# PRODUCT UPDATE

#207

## 2B.704 Insulators Updated with Pinout Trail

Female Insulator Example

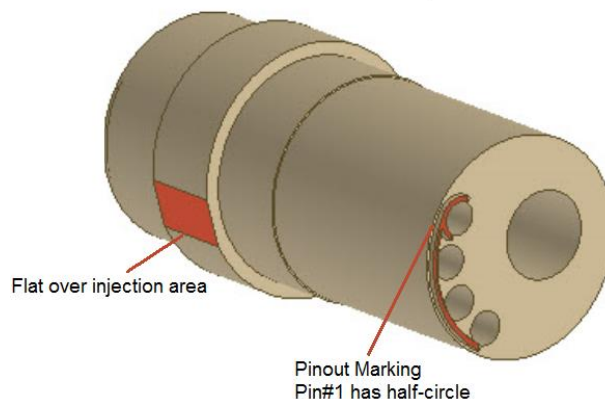
LEMO's 2B.704 insulators now have a marking for the pinout trail and a flat over the injection area. These insulators are used in the B, K, T and W Series. There is no change to fit or function. The form has changed as described in the details below.

To ease identification of pin numbering, the pinout trail has been added for both male and female insulators for the 2B.704 type. Also, a flat has been added over the injection area (as shown in the example below).
